Safety Recall

Mack Trucks Inc.
Greensboro, NC USA

Date	Number	Release	Page
01.2026	SC0485	01	1(14)

Bench Seat Belt Anchor AN, GR, MD, MDE, PI

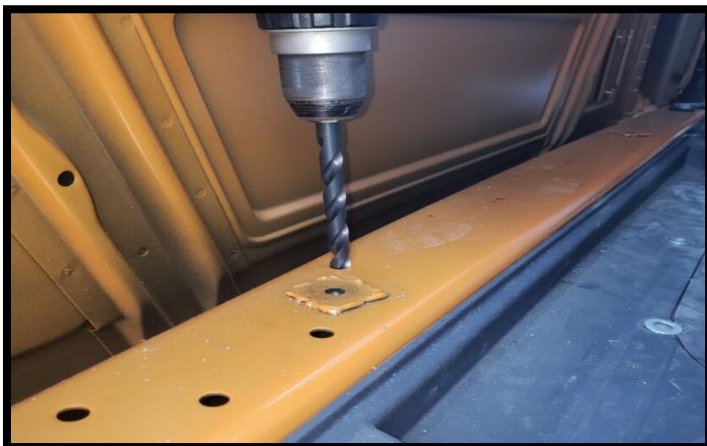
Certain Mack Anthem (AN), Granite (GR), Pinnacle (PI), and Medium Duty (MD) trucks may be equipped with a passenger-side seat belt anchor that does not meet the requirements of FMVSS 210 Seat Belt Anchorages due to inadequate welding during cab assembly. In the event of an accident, the passenger-side seat belt anchor to the floor may fail, increasing the risk of injury.

4. Using a 13mm drill bit, enlarge the two holes beside the plate (inside the red circle image above).

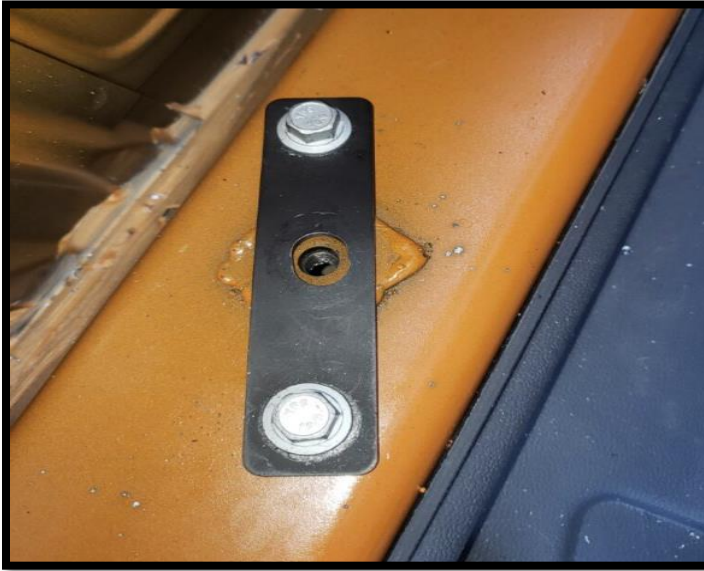
7. Install two washers (supplied in the kit), one on top of each rivet nut.

8. Install the plate (supplied in the kit) ensuring all the holes align.

It may be necessary to grind down any high welds that could prevent the reinforcement plate from sitting flush against the weld plate.

9. Install two M10x30 bolts (supplied in the kit) and torque to spec.

Tightening torque	
Reinforcement, screw	$65 \pm 5 \text{ Nm}$ ($48 \pm 4 \text{ lb}_\text{r}\cdot\text{ft}$)

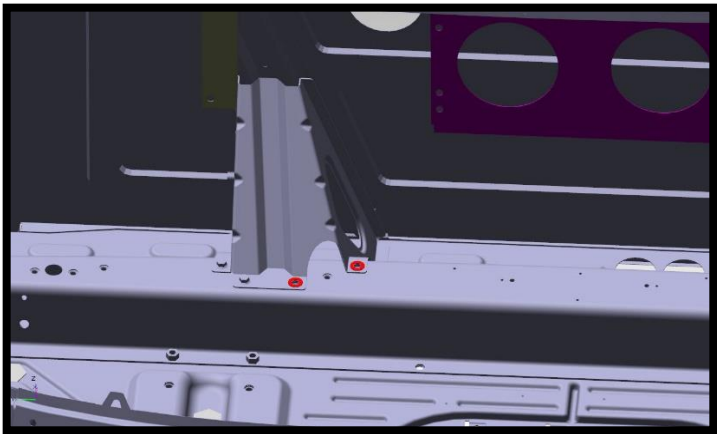
21. Remove and discard the two bolts securing the support bracket to the crossmember.

22. Install two washers (supplied in the kit) on the crossmember where the two bolts were removed (shown below).

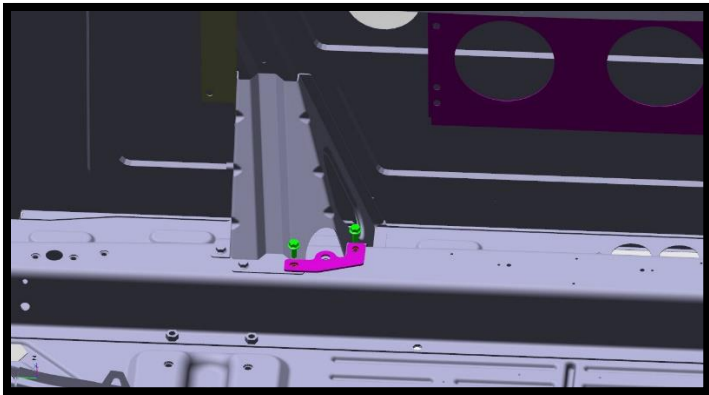
23. Install the reinforcement plate (supplied in the kit).
24. Install the two M8x25 bolts (supplied in the kit) in the crossmember holes.
25. Ensure the holes align and torque the bolts.

Tightening torque	
Reinforcement, screw	30 ± 5 Nm (22 ±4 lb _f ·ft)

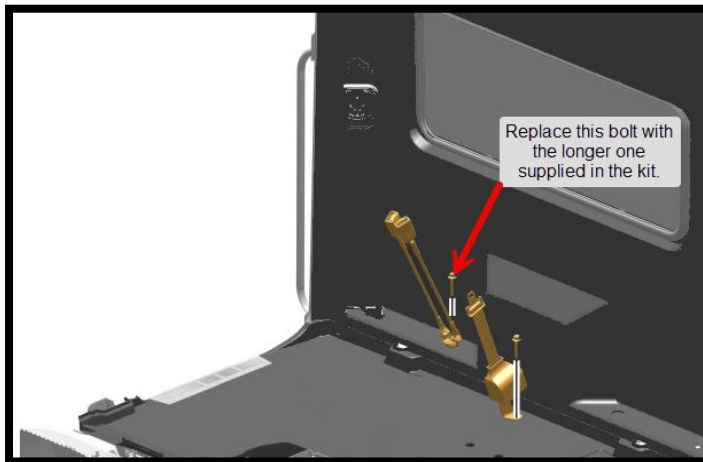
29. Install a new longer M10x60 bolt (supplied in the Kit) in the position shown in the image below.

Tightening torque	
Seat belt, screw	65 ± 5 Nm (48 ± 4 lb _r -ft)
